Eastern Regional Power Committee

Sub: Minutes of the 134th PCC meeting held on 16.04.2024

Minutes
of
134th PCC Meeting

ITEM NO. B.1: Total Power Failure at 220 kV Begusarai(BSPTCL) S/s on 05.03.2024 at 11:56 Hrs

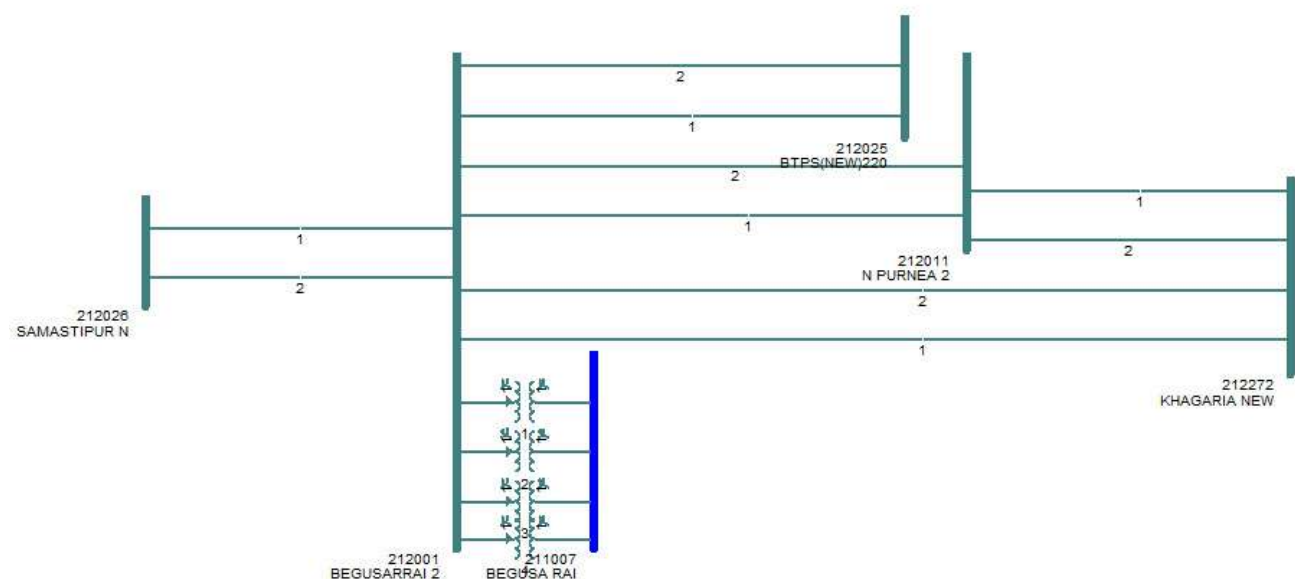
At 11:56 hrs, a fault(Y-B-N) occurred in 220 kV Begusarai-IOCL-1, which was kept idle charged from Begusarai end. The distance protection operated at Begusarai end but the breaker didn't open. Since LBB and bus bar protection is not available for 220 kV Begusarai S/s, other feeders got tripped from remote ends resulting in total power failure at Begusarai S/s.

He informed that due to communication gap between execution agency (M/s ABN Tower) and CGL, execution agency charged the line even though leakage issue was present in the B-pole. He added that breaker is in warranty period and the executing agency has been asked to investigate the issue.

On non-availability of busbar protection, BSPTCL updated that the proposal for busbar protection has already been approved and the work will be started tentatively in the month of June-24.

BSPTCL was advised to follow ERPC Guidelines for protection settings of idle-charged line.

Root cause analysis of damaged CTs

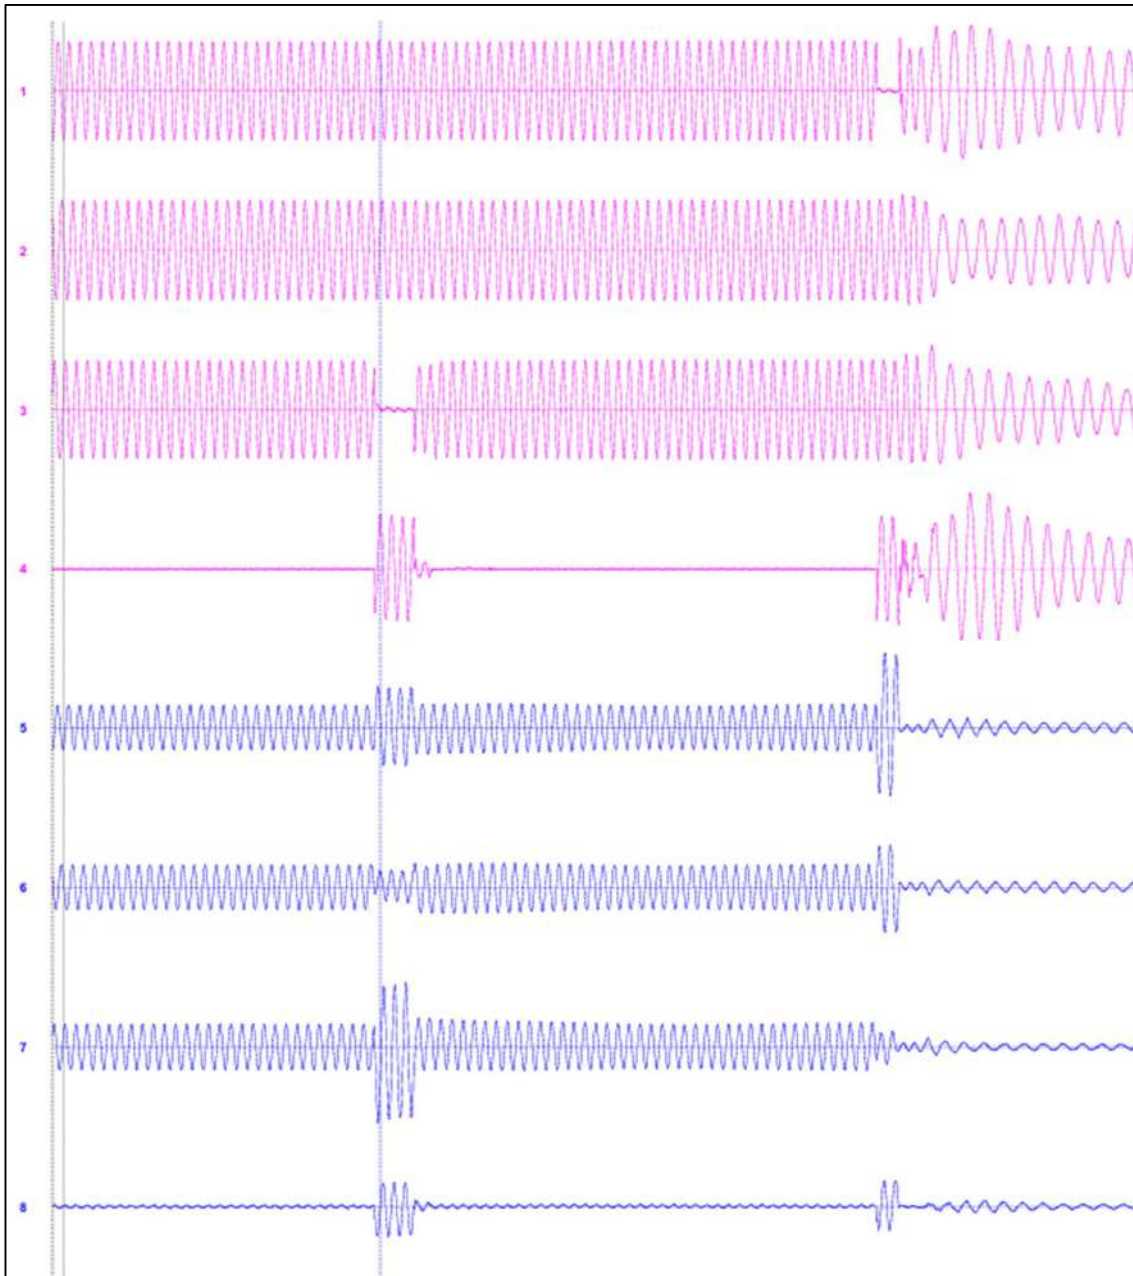
The failed CT was AREVA make, dead tank type. Manufacturing year was 2007. The extent of damage occurred in the CT prohibited any further investigation. However, recommendations and corrective measures ensued after the incident which are highlighted as below.

1. All AREVA make CTs are undergoing oil sampling for DGA purpose.
2. To avoid the extent of secondary damages, we are in process of procuring polymer insulator housing CTs (Line/Dead Tank). Response received from M/s GE T&D, M/s CG Power & Industrial Solutions
3. Frequency of CT oil DGA has been increased.
4. OEM has been contacted for further assistance regarding future planning of the installed CTs.
5. To ensure correct operation of relays and EHV equipments, annual testing and laid down guidelines to be followed.

Probable Root Causes:

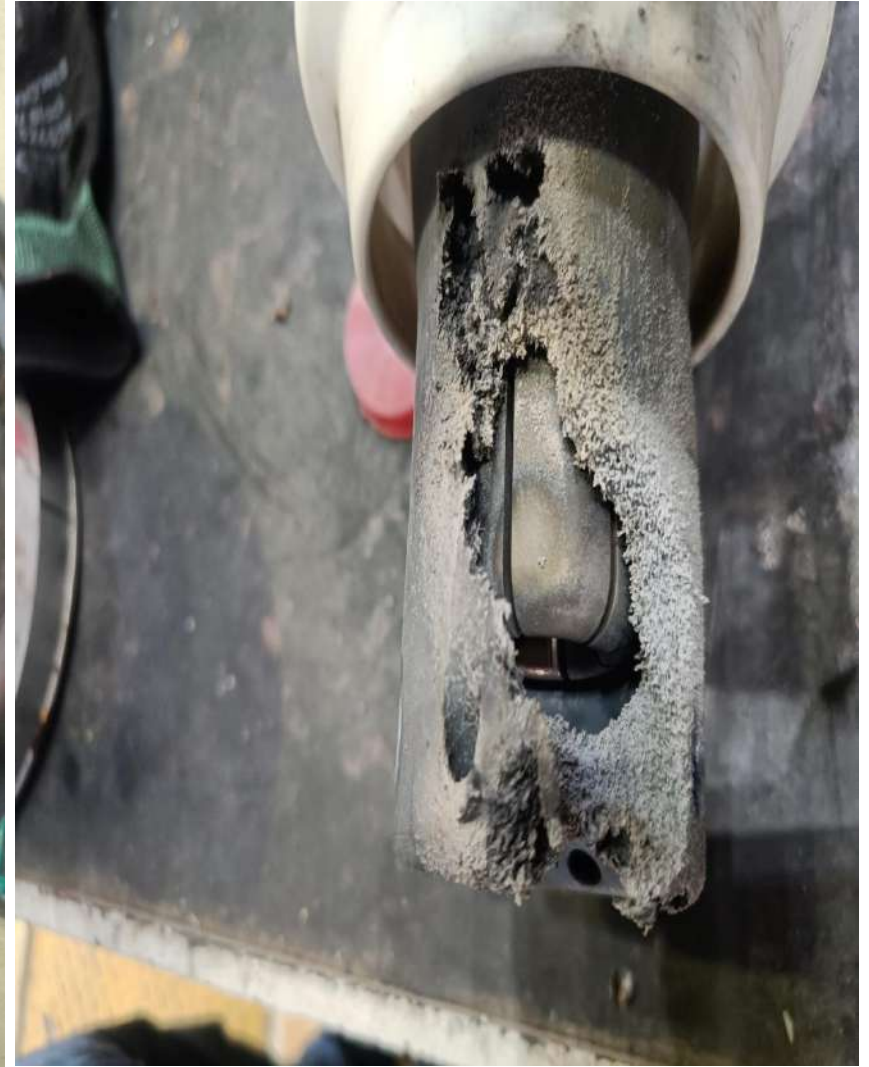
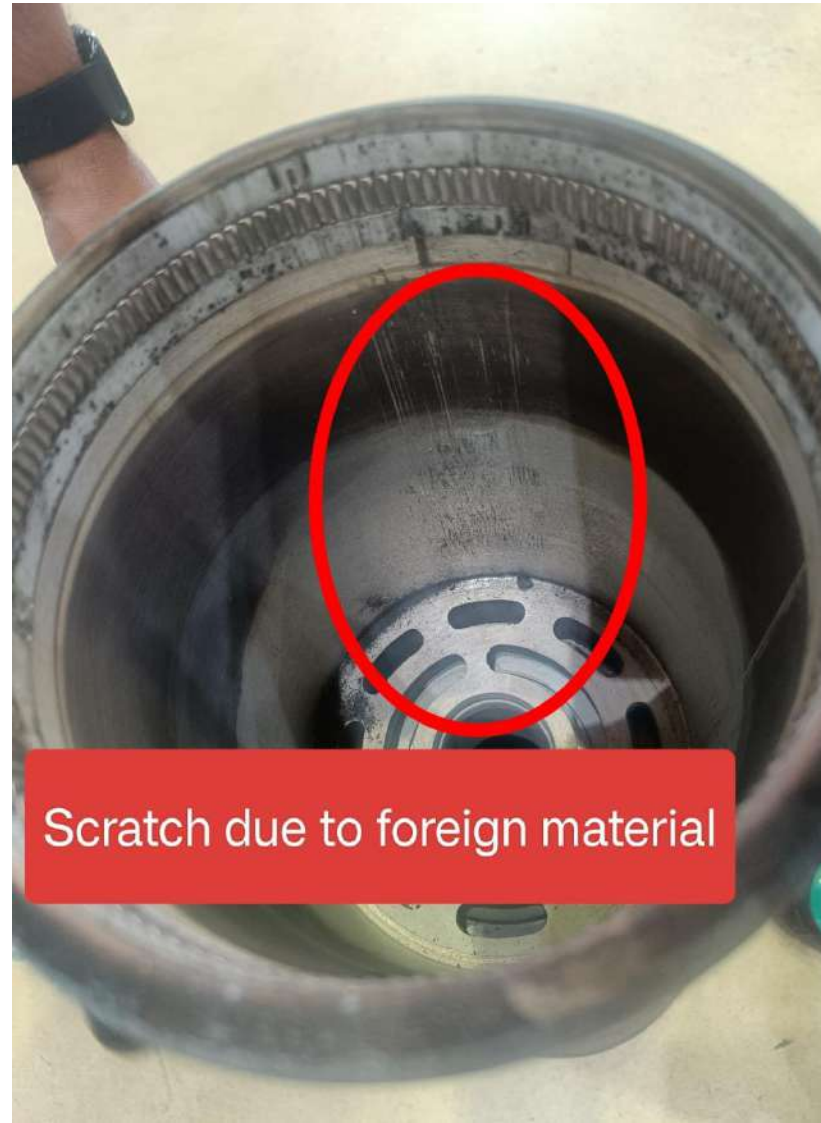
Based on the above observations and subsequent discussions with Siemens, the probable root causes for circuit breaker Interrupter Unit internal flashover are as below:

1. It is apparent that the Scratches on the heating chamber were due to interaction with dislodged multilam material observed inside. NTPC requested Siemens to furnish to share analysis on its impact on breaker performance.
2. In view of the joint observations above and earlier failure on two occasions also, it is suspected that there might have some deficiency in the supplied breakers during this period.
3. Siemens informed they will review and revert on the same. NTPC will provide the relevant data (DR, Sequence of events etc) as required by Siemens through mail.

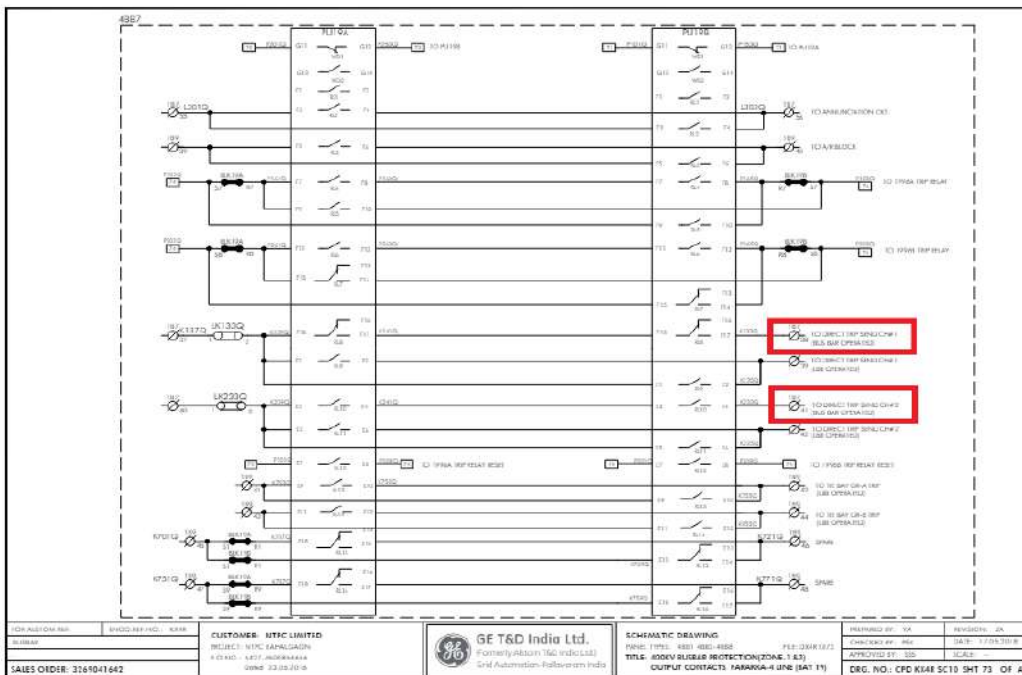
As per report, Tie CB 2052 was in closed condition during the event still DT was sent to remote end. Upon checking, it is observed that even though **Tie CB is in closed condition, the circuit for DT send is through.**

The TIE CB STATUS issue (OFF Status in series with Bus bar contact) will be checked and rectified during Opportunity.
